Attachment A: AQRV Impact Assessment—Nitrogen Deposition in Denali National Park

Attachment B: BACT Evaluation—SCR for the Combustion Turbines, Annual Emission Limits and Flares

Attachment A:
AQRV Impact Assessment—Nitrogen Deposition in Denali National Park (NP)

BACT Evaluation of SCR for the Combustion Turbines, Annual Emission Limits and Flares

Figure A-3: Modeled Nitrogen Deposition for the AK LNG Liquefaction Facility (Flares Maximum Annual PTE) plus the AK LNG Mainline Compressor and Heater Stations

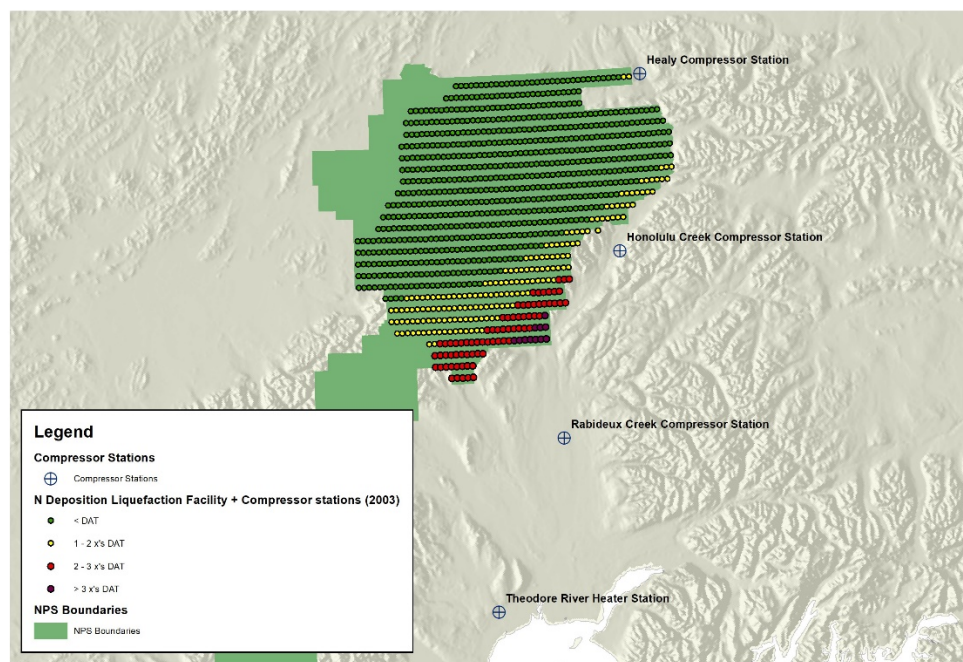
As noted previously, the geographic extent of the modeled nitrogen deposition from the AK LNG facility occurs in the southern and southeastern end of Denali NP, which also coincides with the areas estimated to receive the highest amounts of current cumulative deposition. (See Figures A-3 through A-5)
